Sheet: /
 File: ghOAS.kicad_sch

Title: Open Amiga Sampler

Rev: 1.1

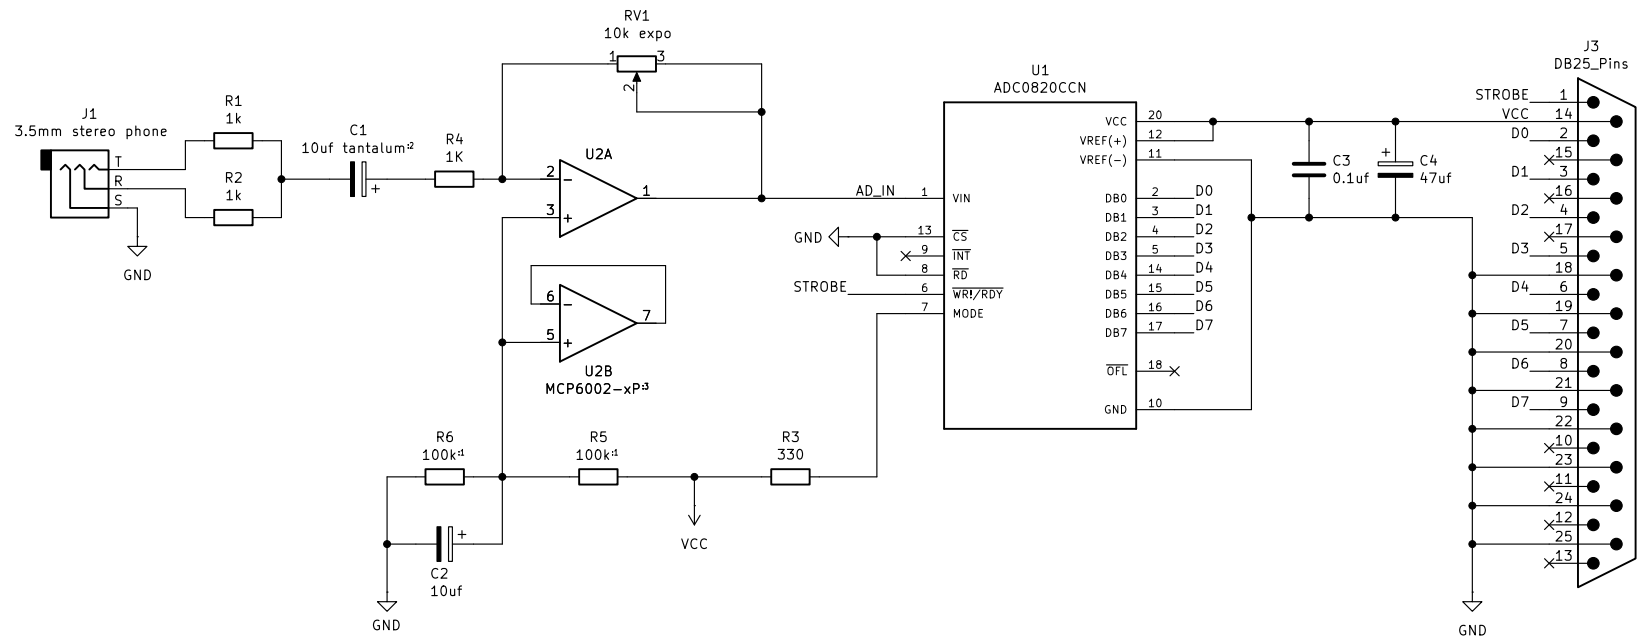
NOTES:
 1. values changed to remove DC offset per issue #17
 2. reversed polarity fixed per issue #18
 3. wired additional op-amp section per issue #19
